Australian Government
National Capital Authority

Report on Consultation

Development Control Plan 21/01

Part Block 11 Section 38 Fyshwick (Dairy Road Precinct)

Figure 1. Minimum floor to ceiling heights. Source: City and Gateway Urban Design Framework (NCA and ACT Government December 2018).

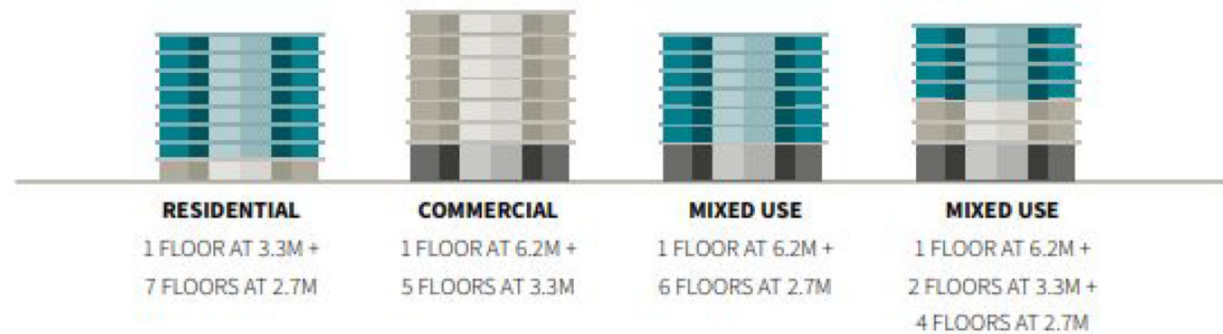
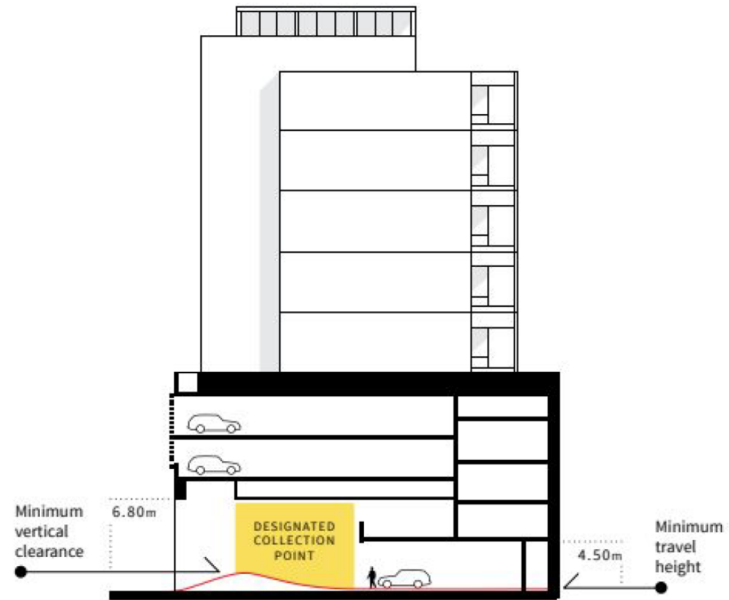
<p>Design Standards</p> <p>Attempts to translate the number of storeys into metres above ground level must also address the fact the zoning of each area accommodates a range of building types each with different functional needs and hence differing floor to floor heights.</p> <p>Given the allowed eight storeys, then 25m divided by 8 storeys equals floor to floor heights of only 3.1m. However, this does not adequately address:</p> <ul style="list-style-type: none"> ● Provision of appropriate ground level floor to ceiling heights sufficient to accommodate active uses. In this regard we note that City and Gateway Urban Design Framework jointly prepared by the NCA and EPSDD advocated floor to ceiling heights of a minimum of 6.2 metres to accommodate active uses at ground floor level (see Fig 1 below); ● Provision of appropriate ground level floor to ceiling heights sufficient to accommodate service areas and commercial waste collection vehicles. The Transport Canberra City Services Waste Management Standards, in order to promote safe and efficient collection services, require waste collection vehicles to enter and exit a site in a forward manner and maintain an overhead clearance of 6.8 metres to collection points to accommodate front loading of waste hoppers (see Figure 2 below); ● Allowance for future adaptability of buildings such as parking structures. This is a sustainability measure to encourage the retention and refurbishment of buildings which is consistently advocated by planning authorities and the National Capital Design Review Panel; ● Allowance to accommodate overhead and/or under floor air conditioning and service ducts essential for commercial buildings; ● Appropriate floor to ceiling heights are also necessary to protect the quality of new buildings and produce lighter and more habitable and healthier indoor spaces. Appropriate ceiling heights create spatial hierarchy and respond to a diversity of building types. In this regard we note that City and Gateway Urban Design Framework jointly prepared by the NCA and EPSDD advocated floor to ceiling heights of a minimum of 3.3 metres to accommodate commercial uses at upper levels;

- Allowance for slab thicknesses. All of the standards quoted above are floor to ceiling heights. Floor to floor heights are necessarily greater to accommodate the thickness of floor slabs. Floor slabs are typically in the order of 300mm thick; and
- Allowance for the building's trafficable roof also typically in the order of 300mm.

All of these matters are essential considerations for non-residential commercial and industrial buildings. It is important to note that that part of the site within 200 metres of the Monaro Highway boundary is exclusively dedicated to *non-residential* uses. Residential use is a prohibited use in the majority of the site under the provisions of DV 377.

Figure 4. Relationship of Dairy Road to Monaro Highway and Storage King. Source ACTMapI

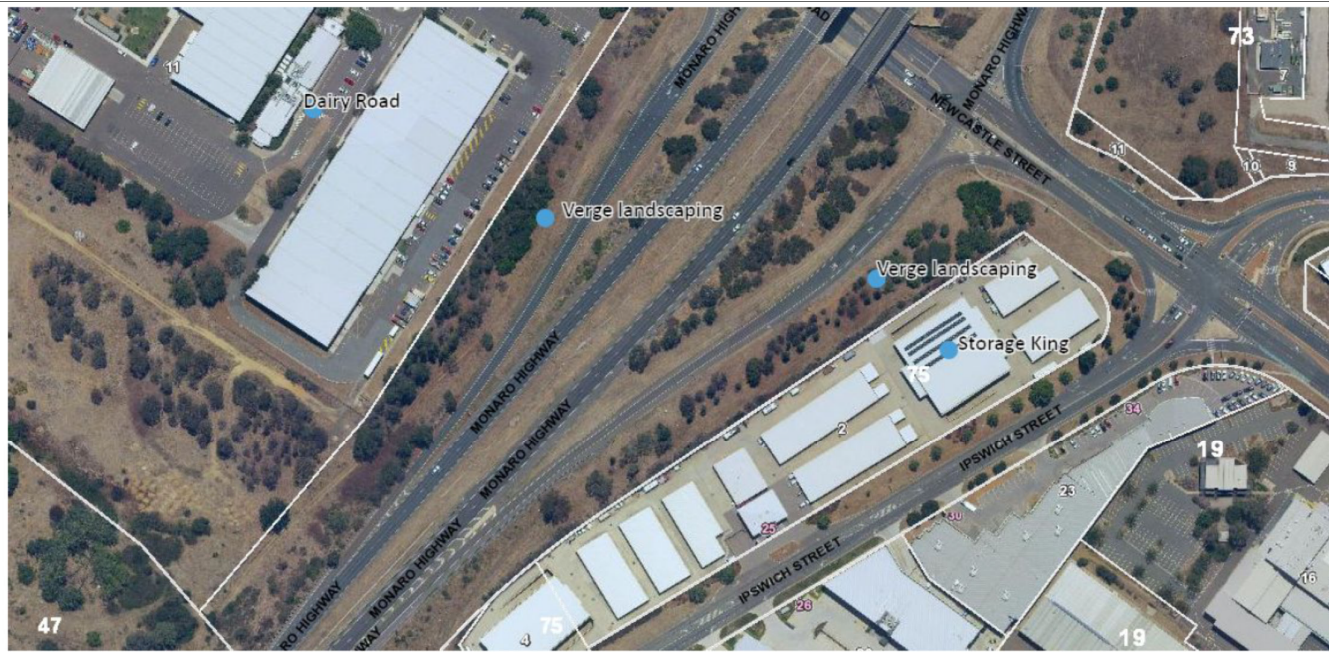
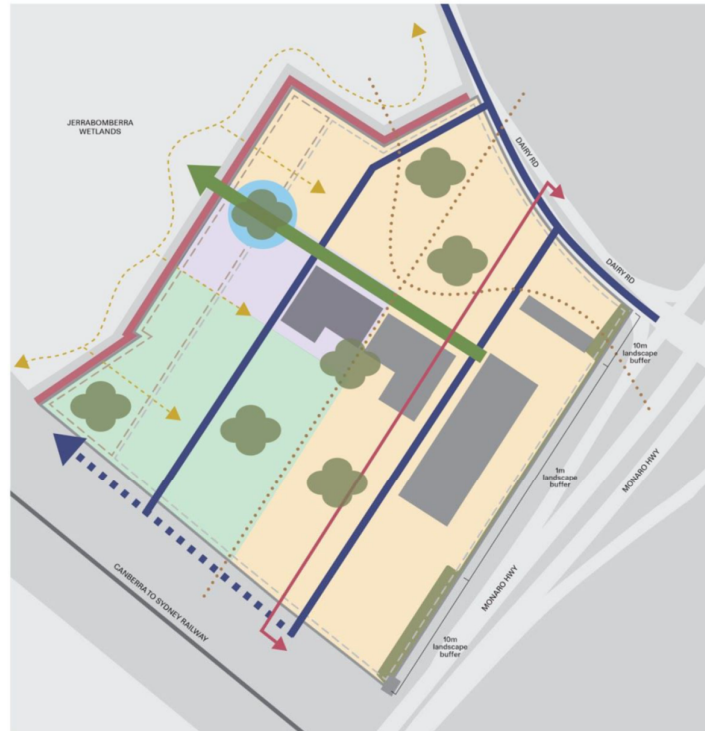
<p>Options for Management of Verge Landscaping</p> <p>This reality is reflected in the existing landscape treatment, the primary purpose of which is to contain the visual impacts of the highway. As it is the highway which generates the impacts it is appropriate that the highway verge accommodate the primary means to contain them. In every jurisdiction primary mitigation measures are accommodated within the road reservation. It is a reasonable conclusion that it was for this very reason that the NCA’s predecessor elected to adopt extensive verge landscaping. That this was the case is readily evident from site inspections and examination of aerial photographs (see Figure 4 below).</p> <p>The Monaro Highway verge is 30 metres in width and densely planted with tall mature evergreen trees. Molonglo has offered to take up a Licence or Deed of Agreement over the verge to ensure the enhancement, long-term management and maintenance of the verge planting. This approach was adopted for the verges around Molonglo’s NewActon development and the outcomes widely applauded. If undertaken in conjunction with a flexible approach to boundary setbacks then highly innovative integrations of high quality landscape and built form become possible.</p> <p>DCP 171/03/0007 Storage King</p> <p>The site on the opposite side of the Monaro Highway is Block 2 and Block 4 Section 75 Fyshwick currently leased to U-Stow It trading as Storage King as a commercial self-storage business. The site has a combined area of 15,749m². Previously vacant land it was sold by the former Land Development Agency early this century and is now fully developed. It is zoned Industrial IZ2. The site is subject to the provisions of DCP 17/03/0007. The setback provisions of DCP 171/03/0007 (Storage King) differs in one important respect from those of Draft DCP 21/01 (Dairy Road). The Storage King DCP provides that “Buildings must be setback a minimum of 10 metres from the Monaro Highway boundary, <u>except where otherwise agreed to by the Authority</u> (emphasis added)”. The omission of a similar provision in the Dairy Road DCP 21/01 denies the NCA the ability to consider variations to the 10m setback that may be necessary in specific circumstances to give effect to the wider planning aspirations for Dairy Road and address relevant regulatory building requirements.</p>

Unlike the Dairy Road Precinct, there is little likelihood of the Storage King site being rezoned for comprehensive development. The Storage King site is zoned Industrial IZ2 which may see the site used for additional uses in the future consistent with the IZ2 development table. However, the limitations of the site area, the controls of the Industrial Zones Development Code and in particular the access limitations imposed by the traffic regime in Ipswich Street are likely to act against subdivision and significant redevelopment. By contrast, Dairy Road is a substantial site with an area 14.33 hectares and will be subject to comprehensive redevelopment in accordance with its Commercial CZ3 zoning under DV 377, Dairy Road Precinct Code and the Dairy Road Development Framework.
